Early Site Permit (ESP) Application for the Clinton ESP Site
Docket No. 52-007

Subject: Response to Request for Additional Information Letter No. 12

Re: Letter, U.S. Nuclear Regulatory Commission (N. V. Gilles) to Exelon
Generation Company, LLC, (M. Kray), dated December 9, 2004, Request
for Additional Information (RAI) Letter No. 12 – Exelon Early Site Permit
(ESP) Application for the Clinton ESP Site (TAC No. MC1122)

Figure C-1. Predicted Rate of Vehicles Leaving the EPZ for Winter Day Adverse Weather

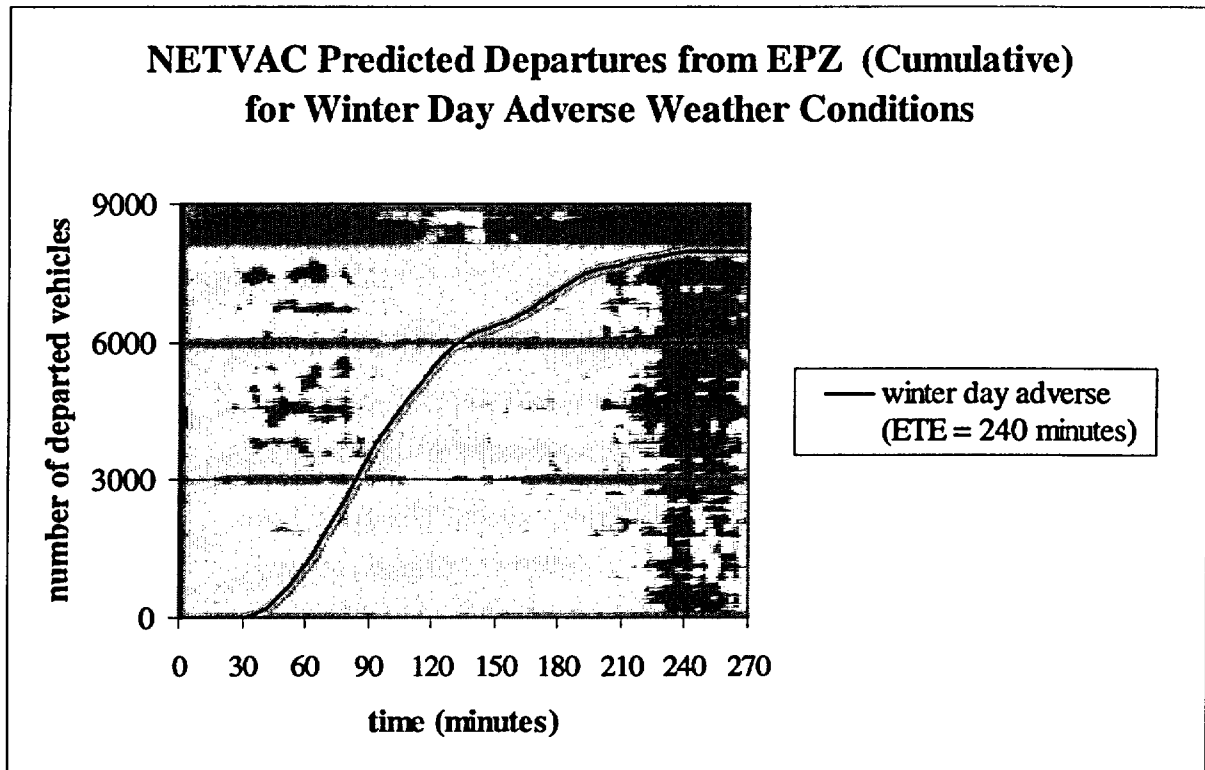
v) Since the additive reporting format for time estimates when probability distributions are used is not included in the 1993 ETE Study, provide the percentage of the population as a function of time.

A graph displaying the number of vehicles evacuating as a function of time for the Winter Day Adverse Weather scenario is provided as Figure C-1 in Attachment C.

**Figure 2.3-1
Evacuation Routes to Registration
and Congregate Care Shelters**

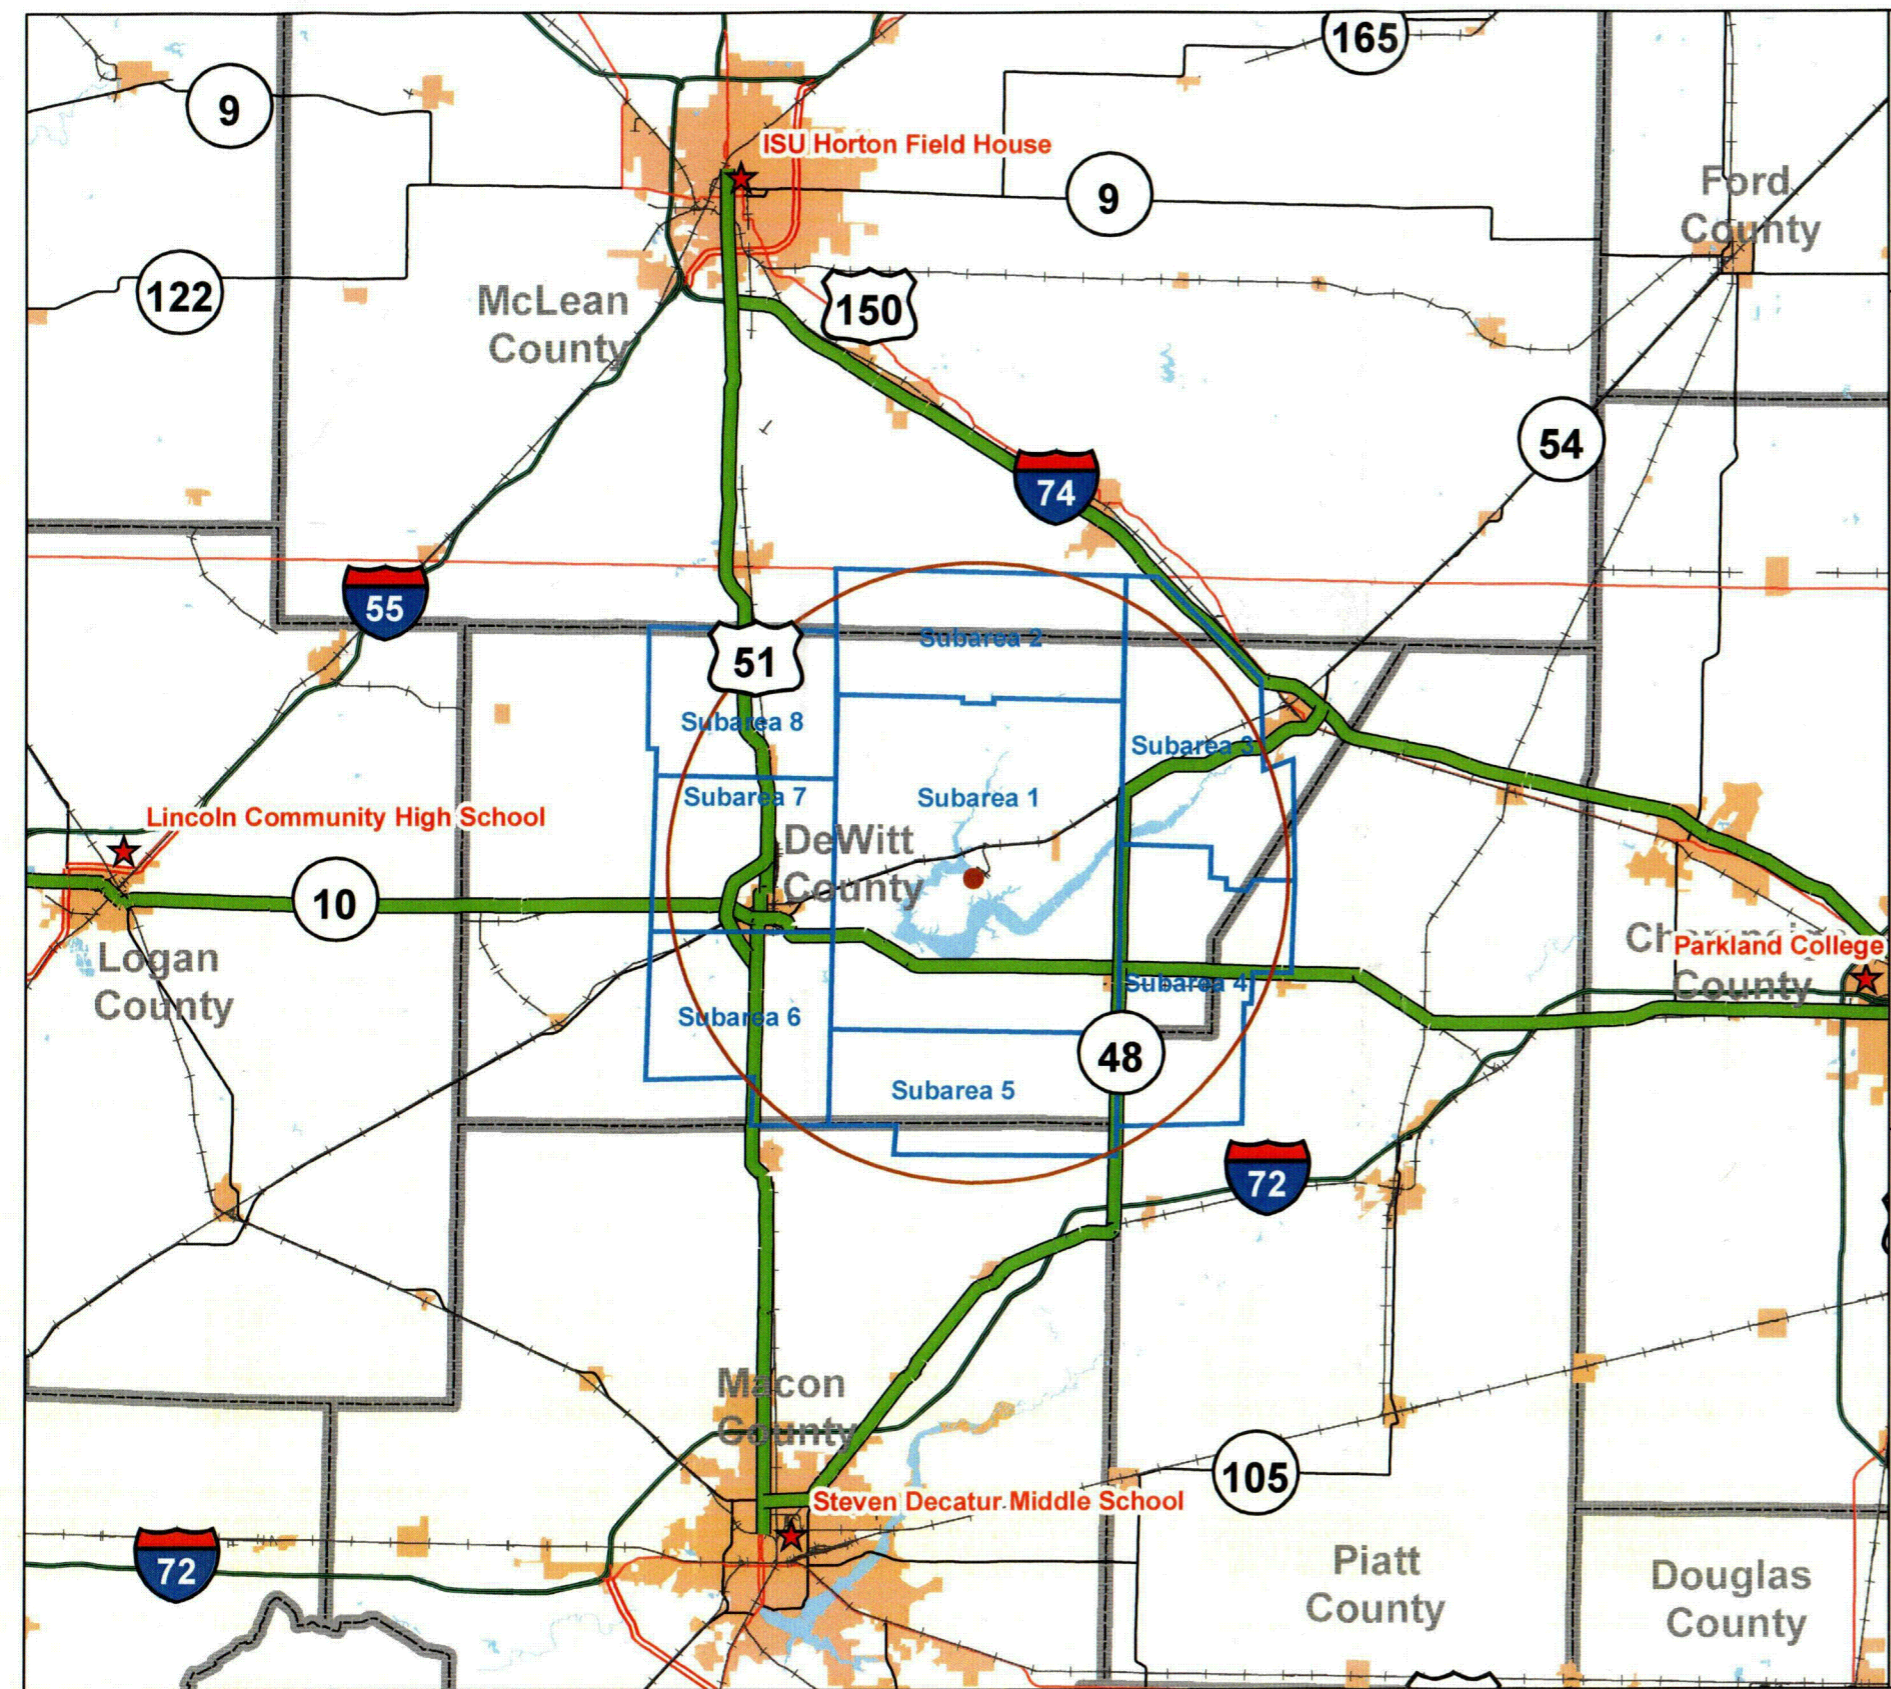
k) Regarding Section 1.3, "Reception Centers," in the 1993 ETE Study, Figure 2.3-1, "Evacuation Routes and Congregate Care Centers," in the Emergency Plan for the ESP application, and Map C, "Clinton-Shelter and Evacuation Map," in *The Illinois Plan for Radiological Accidents*, Volume VIII, identify which of these items correctly specifies the location of the Registration and Congregate Care Centers.

The three items listed: Section 1.3 of the 1993 ETE, Map C of the IPRA Vol. VIII, and Figure 2.3-1 of the EGC ESP Emergency Plan, all correctly specify locations for evacuated persons to gather, but each use different terminology. The following table shows the differences in terminology used.

Due to the difference in terminology, the EGC ESP Emergency Plan will be revised to reflect the terminology used in IPRA Vol. VIII. For example, *Registration and Congregate Care Centers*, will be revised to *Registration and Congregate Care Shelters*.

Additionally, each source specifies evacuation locations that comply with the other sources except for one discrepancy. For example, the 1993 ETE Study directs evacuation people to reception centers located in Bloomington (North), Champaign (East), Decatur (South), and Lincoln (West). Map C of IPRA Volume VIII shows congregate care shelters in each of these cities. However, Figure 2.3-1 of the EGC ESP Emergency Plan only labels the following registration and congregate care centers:

Therefore Figure 2.3-1 of the EGC ESP Emergency Plan will be revised to include the Lincoln Community High School as the registration and congregate care shelter for the city of Lincoln (West of EGC ESP Site).

The EGC ESP Emergency Plan will be revised to reflect the terminology used in IPRA Vol. VIII. For example, *Registration and Congregate Care Centers*, will be revised to *Registration and Congregate Care Shelters* in Section 2.3.1, in the title of Figure 2.3-1, and in Section 10.1.8.1.

Figure 2.3-1 of the EGC ESP Emergency Plan will be revised to include the Lincoln Community High School as the registration and congregate care shelter for the city of Lincoln (West of EGC ESP Site).
